**Harbourside Shopping Centre Redevelopment SSD-7874
Amended Concept Proposal and Stage 1 Early Works October 2020 and
Response to submissions**

My submission is to OBJECT based on the grounds that the minor changing to the northern podium do not :

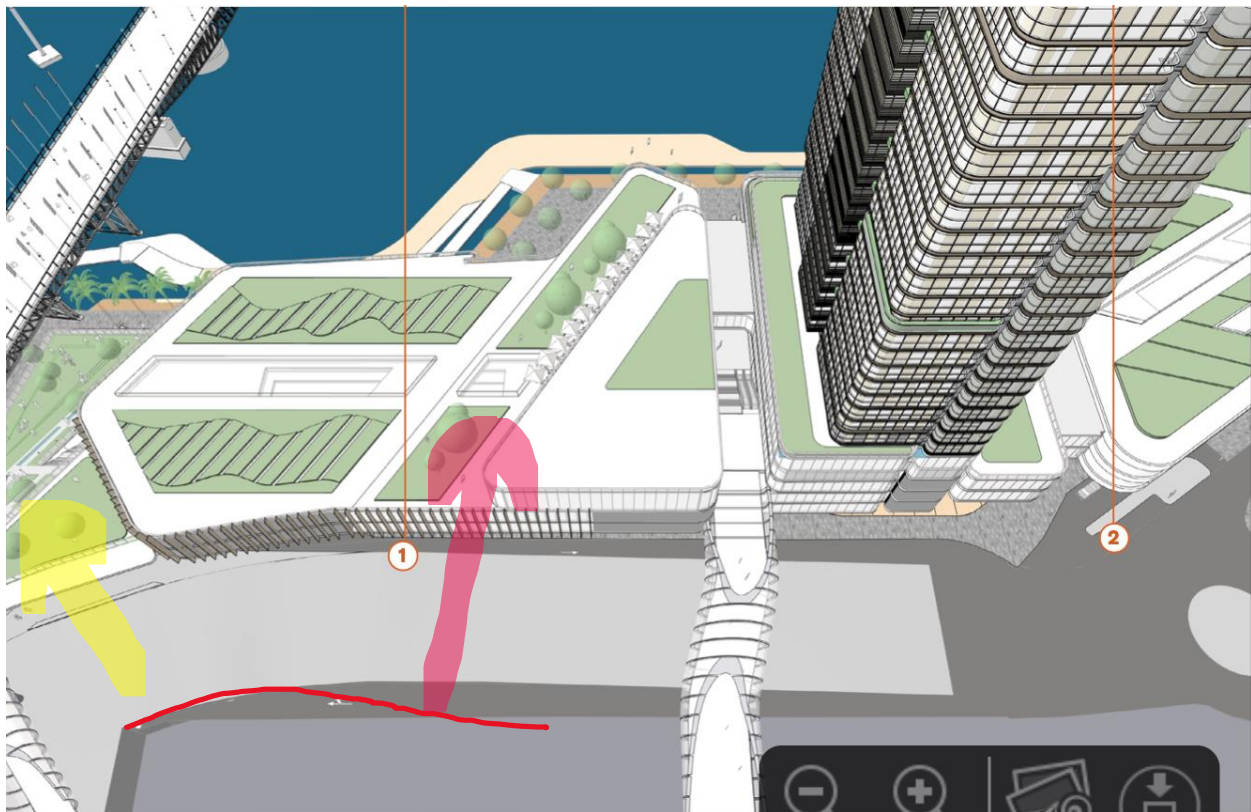
The majority of the **east facing** apartments of 50 Murray Street have highly valued views that enjoy **whole water views of Cockle Bay**. Every aspect (Floor to ceiling glass) of the apartments, in addition to the balcony, have a view of the water. With the previous concept, all east facing apartments at level 8 and below totally lost all Cockle Bay views. The amended concept as shown below still has east facing apartments losing all Cockle Bay water views.

*Views from curved 50 Murray Street are inconsistent with the provision of a channel view platform to the north east claiming to have '*significantly improved view sharing of 50 Murray Street*'*

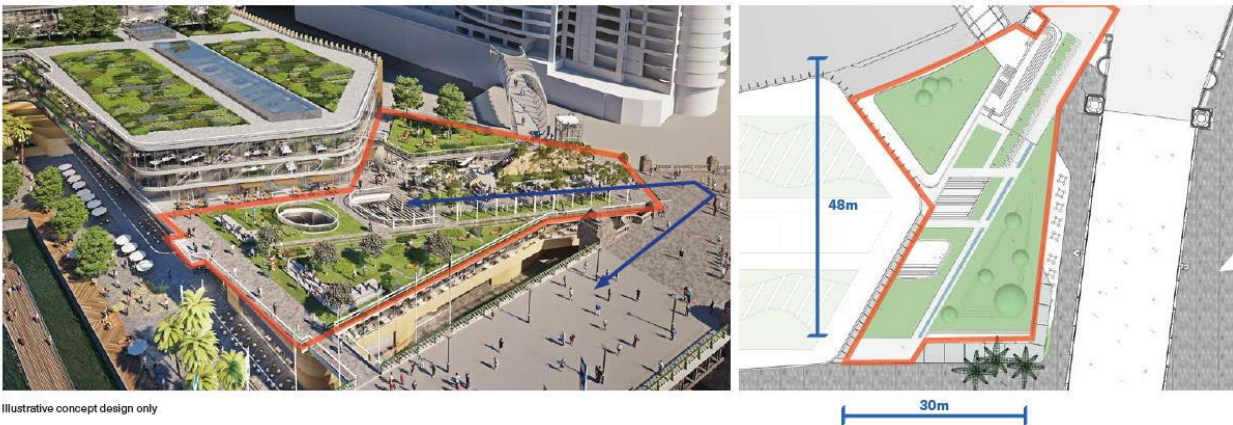
The proponent claims that by introducing a north east facing 'channel' it provides views north of Pyrmont Bridge and thus claims it has '*significant improved view sharing of 50 Murray Street*'. This is an **unacceptable claim**. It has been pointed out that east faced of 50 Murray Street is a curved. Providing a north east channel at the north end of the proposal has no impact on sharing the water views of Cockle Bay.

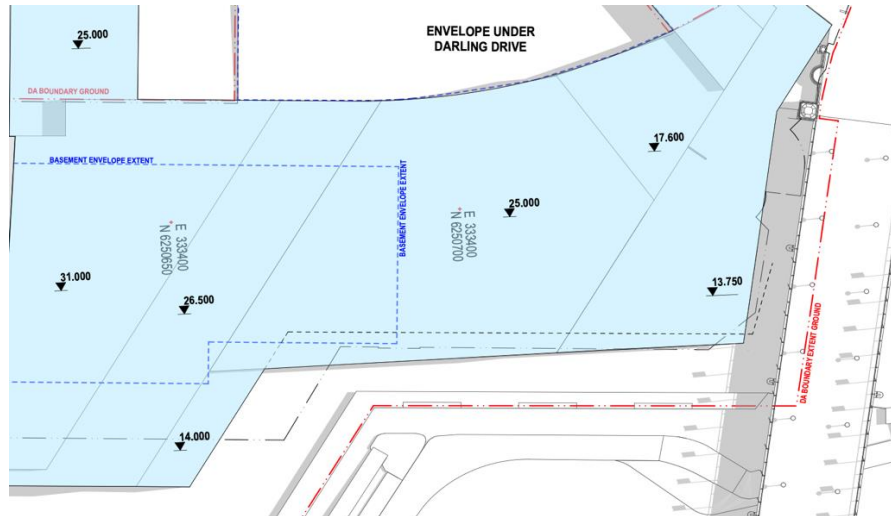
In contrast, the Harbourside Shopping Centre Redevelopment proposal is for a two level park RL's of 13.75 and RL 17.6 extending away from the Pymont Bridge by only some 30m before rising to 25, proposing and RL of for the northern portion of the podium rising to RL 26.5 and then RL31.

The impact of approving the envelop for the Harbourside Shopping Centre Redevelopment will produce two inconsistent character of addressing the Cockle Bay basin as well as an inconsistent start and end of the Pymont Bridge.
